# **Powerlink Revenue Reset**

## **CHC Review of Replacement Capex Reports and Submissions**

### **Purpose of this Report**

**Figure 4-12: Historic and Forecast Expenditure on Replacements**

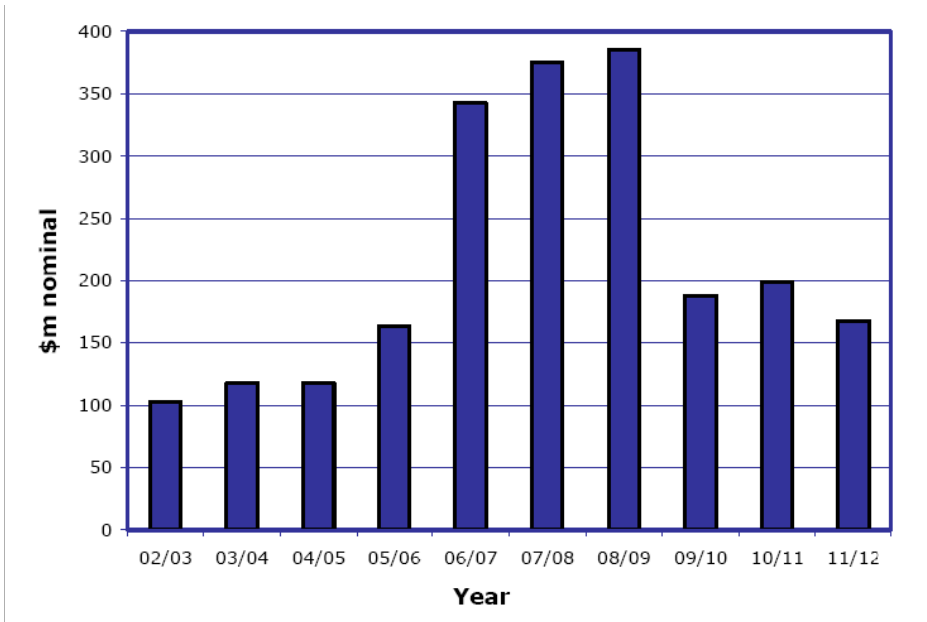
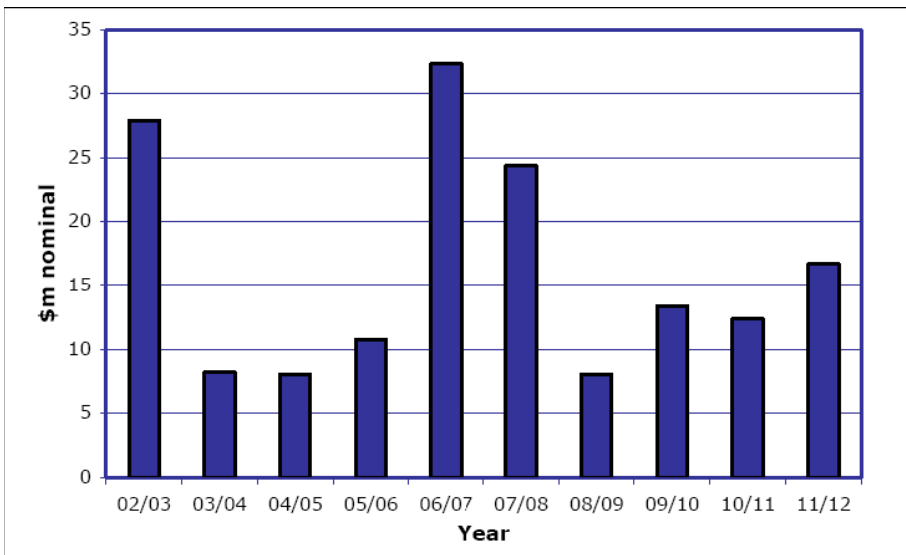
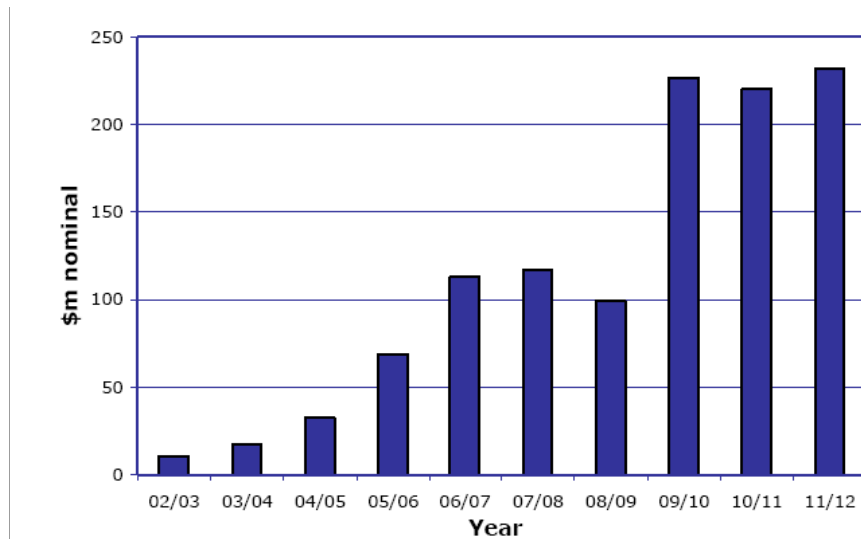
It is evident that Powerlink has timed the bulk of the replacement expenditure from 2009/10 to fill the void left by a fall-off in the expenditure in the other two categories. It is reasonable to conclude from these expenditure profiles that Powerlink has considerable discretion in the timing of its replacement capex that is not available for demand-driven and connection capex.

Scheduling the expenditure in this way may well be a prudent action, having regard for the need to manage construction resources. It may, for instance, be a factor in the achievability of the total capex program. However, it also begs the question: what would be the result of deferring some of the replacement expenditure to the next regulatory period?

**Figure 2.6: Age profile of Powerlink’s network assets**

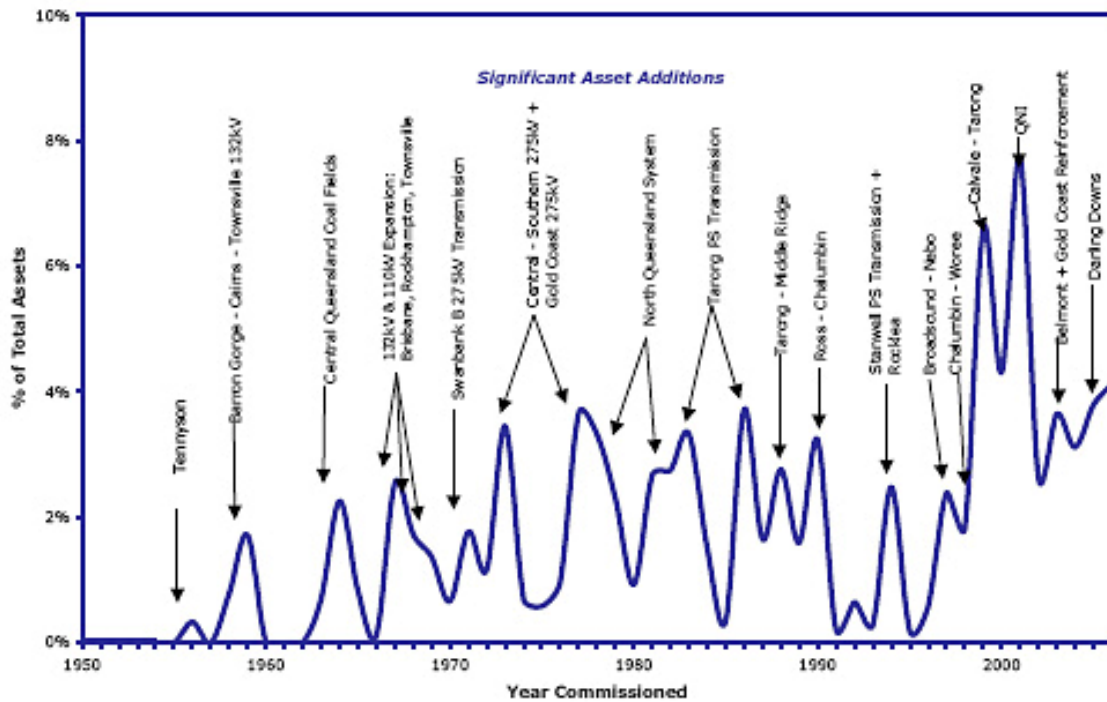
Comment: This assumption is not a good approximation as evidenced by the age profile exhibit provided by Powerlink in its original submission (copied overleaf). Considering 5 year intervals corresponding to the resets it is evident that there would be quite large differences in the value of assets that would be assessed for replacement over successive resets.

The situation is further complicated if there is an element of catch-up in the works. This brings in projects outside the 5 year interval. CHC notes that the ACCC determined an allowance for Powerlink's replacement capex of \$87.3 million for 2002/03 to 2006/07, but Powerlink has indicated that it will spend an additional \$148.6 million, of which \$113 million is estimated for 2006/07<sup>18</sup>. It is a reasonable assumption that Powerlink is urgently addressing a significant
